Office Action Summary

10/560,045

BABA ET AL.

DETAILED ACTION

Figure 1. Annotated view of Igra FIG. 1

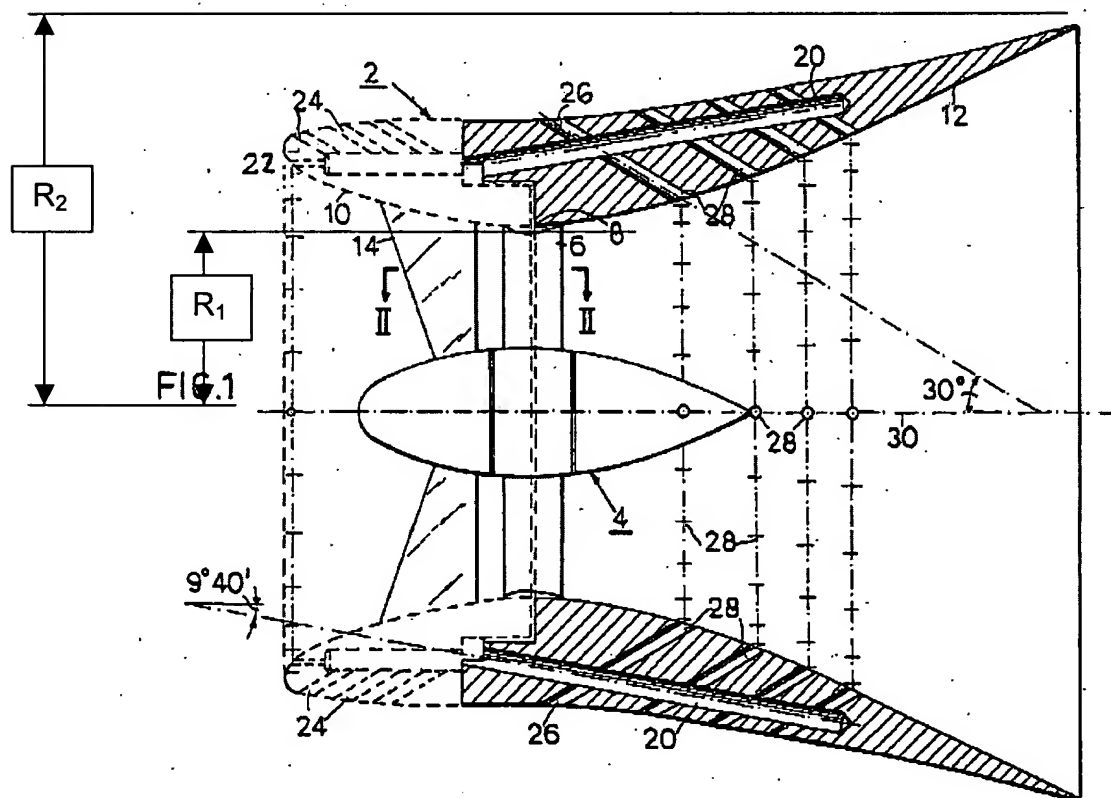
a maximum wing thickness position is nearer a leading edge than a center of the chord in the side cross-sectional wing-like shape of the duct (see FIG. 1), an opening diameter of a front end of the duct made smaller than an opening diameter of a rear

the pencil body 4 is installed such that a front end portion is positioned rearward from a front end portion of the duct and a rear end portion is positioned forward from a rear end portion of the duct (see FIG. 1), and

a ratio of maximum outer diameter of the duct with respect to a minimum inner diameter of the duct is within a range between 2.0 and 4.3 (see Figure 1 below).
